Electric System (IBBS / CAS Message / Fillerneck bonding)
SERVICE BULLETIN BRISTELL B23

Aircraft Design Certification GmbH Reichensteinstr.48 69151 Neckargemünd		Electric System (IBBS / CAS Message / Fillerneck bonding)	Doc-Nr: ADxC-73-SB-037 Issue: A Date: 23.11.2023 Change Nr.: DC-104
Service Bulletin Bristell B23

Electric System (IBBS / CAS Message / Fillerneck bonding)

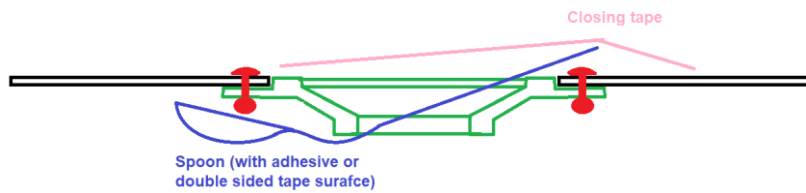
- On the filler use a sharp test head poking with force through the actual surface OR use a tube, simulating the fuel-filler “pistol” and rotate with moderate force against the inner flange edge. Do not measure on the rivets or skin or filler cap.

- The acceptable resistivity is $R < 50\text{m}\Omega$. The measured resistivity of the wiring alone must be accounted for (tara). Hence, measurement point to point max 0.05Ω + measurement wiring.
- Test must be performed for each tank.

3.6 Dimmer Potentiometers securing

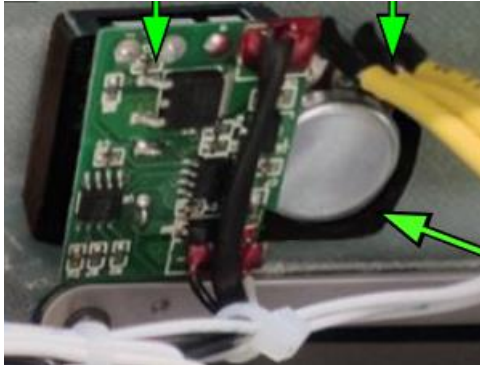
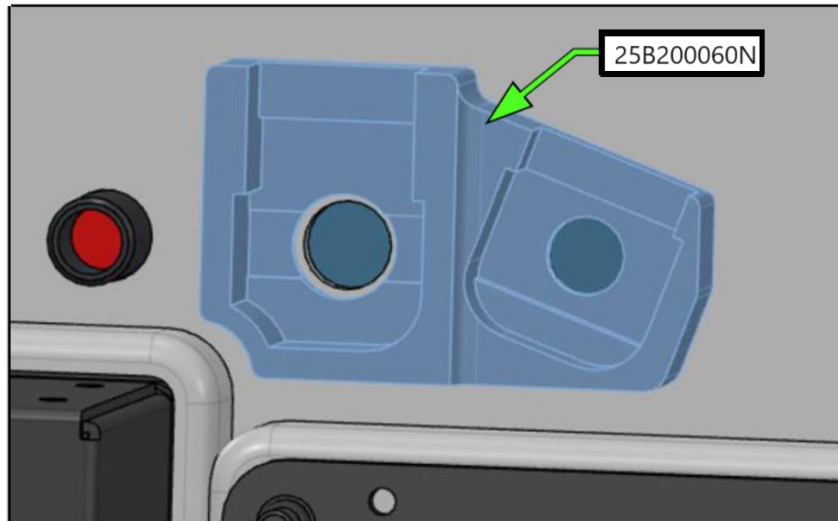
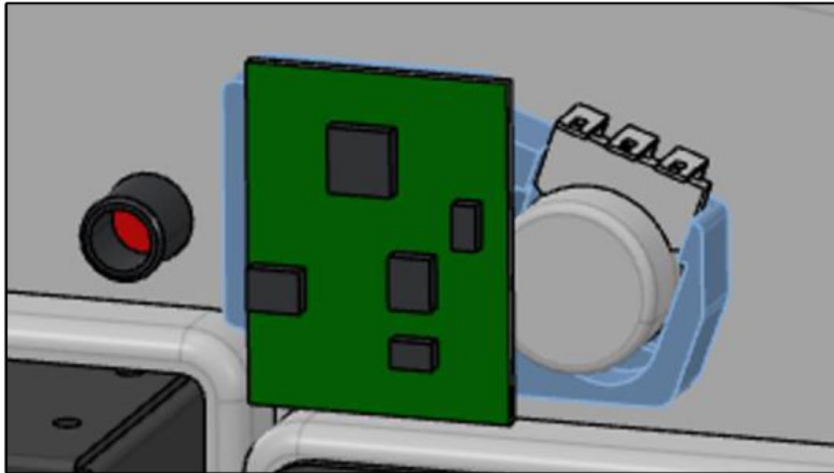
- Check if the light dimmer potentiometers on the instrument panel are loose.
- Torque properly if loose.
- Consider installing part 25B200060N to secure the potentiometers.
 - o Remove instrument panel cover.
 - o Remove the LED strip dimmer potentiometer and the multidimmer potentiometer from the instrument panel.

- o Sand the area where the potentiometer bed will be bonded and clean grease and dust free.
- o Bond the potentiometer bed on the sanded surface with polyurethane sealant Emfimastic PU 50 and make sure to align the holes properly.

- o Let the sealant harden at room temperature for at least 12 hours.

- Reinstall the LED strip dimmer potentiometer and the multidimmer potentiometer.

3.7 R1 resistor replacement (optional)

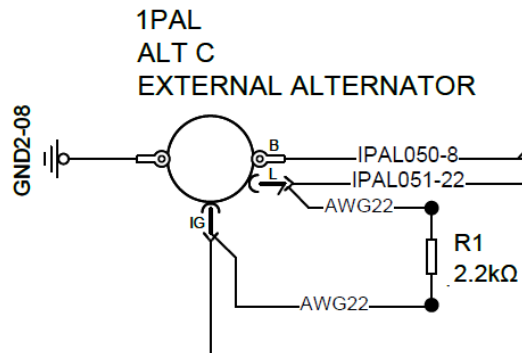
- Identify the existing R1 resistor at the ALT 2 or ALT C alternator, see example for ALT C.

- Install the new resistor according to drawing 34B220000N (Rotax 912), 34B520000N (Rotax 915iS), 34B920000N (Rotax 915-G500), 34B620000N (Rotax 912-G500). Place the R1 resistor further away of the alternator and closer to the firewall of the aircraft.

Installation on B23

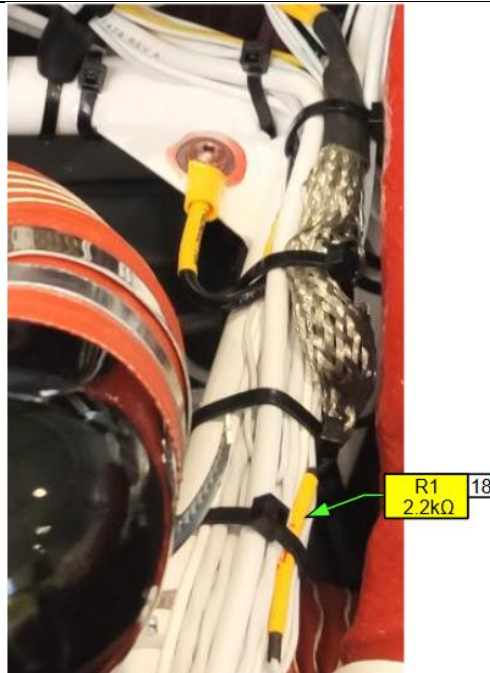
- Apply markings to the wires as per drawing 34B220000N (Rotax 912), 34B520000N (Rotax 915iS), 34B920000N (Rotax 915-G500), 34B620000N (Rotax 912-G500).
